Front Edge of Engine Under Cover Warped

YEAR(S)	MODEL(S)	ADDITIONAL INFORMATION
2010	Prius

Some 2010 Prius vehicles may exhibit an engine under cover that has warped at the front edge after oil maintenance has been completed. An updated engine under cover is now available to address this condition.

Figure 1.

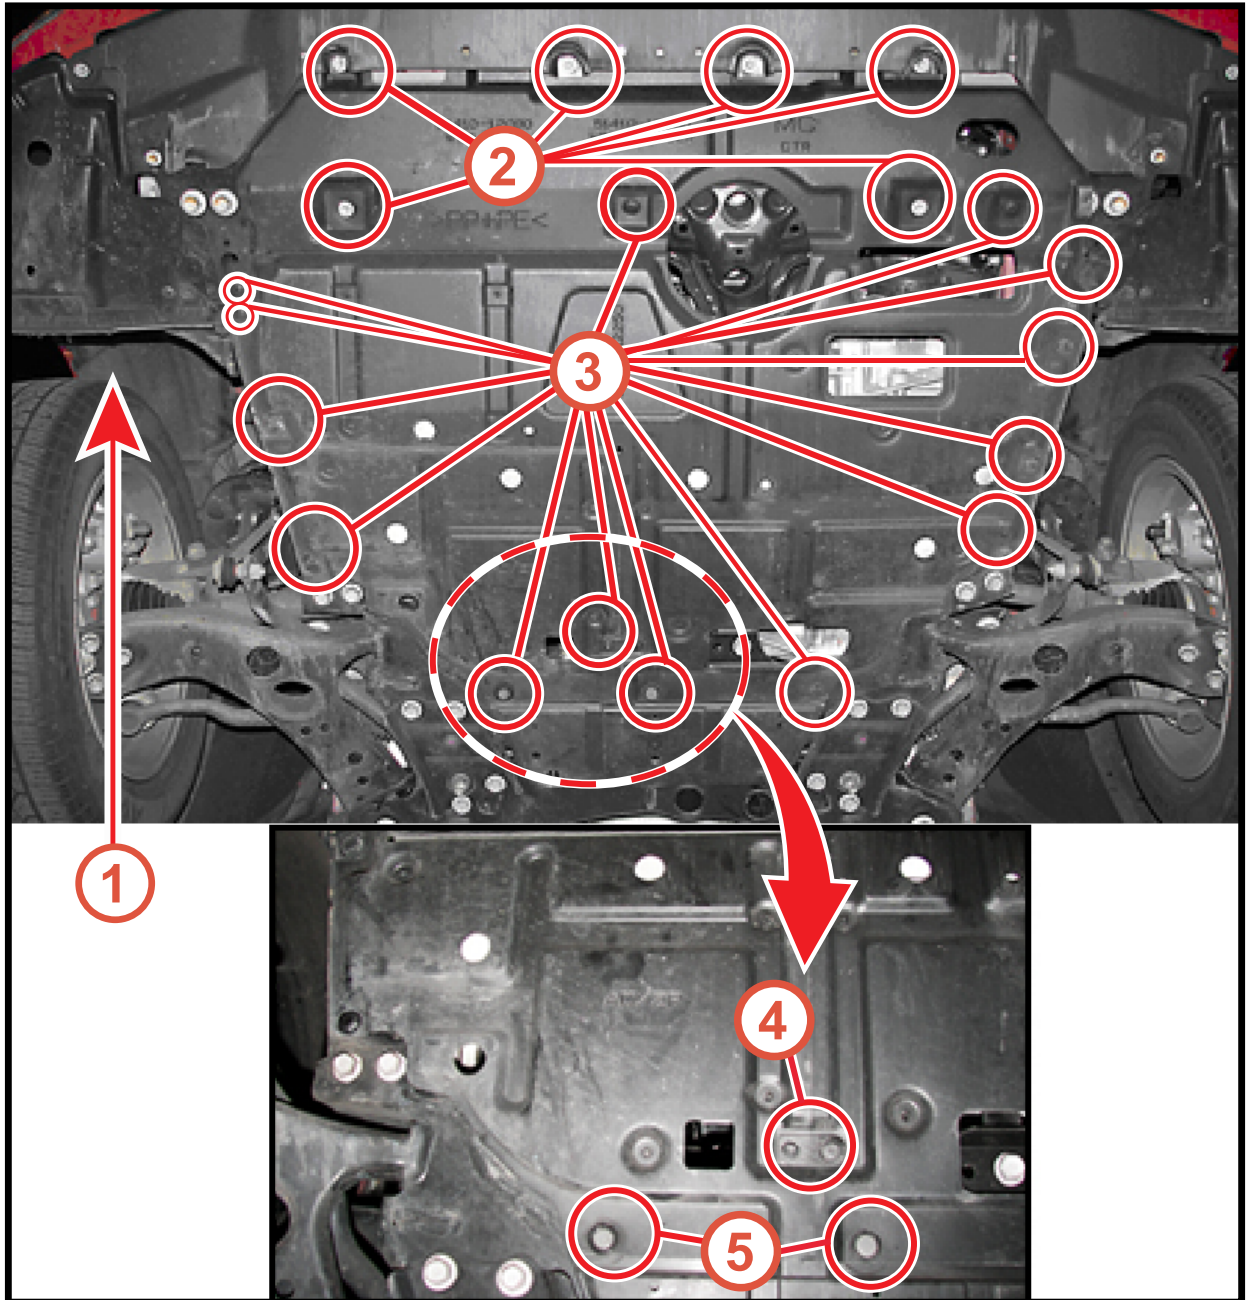
Clips are not interchangeable. See Figure 1 for specific clip locations.

3. Position new engine under cover into place and install the 14 retaining clips in their correct locations, then install the 6 bolts (See Figure 1).

Gently pull down on the edges of the engine under cover to ensure the clips are installed in the correct locations.
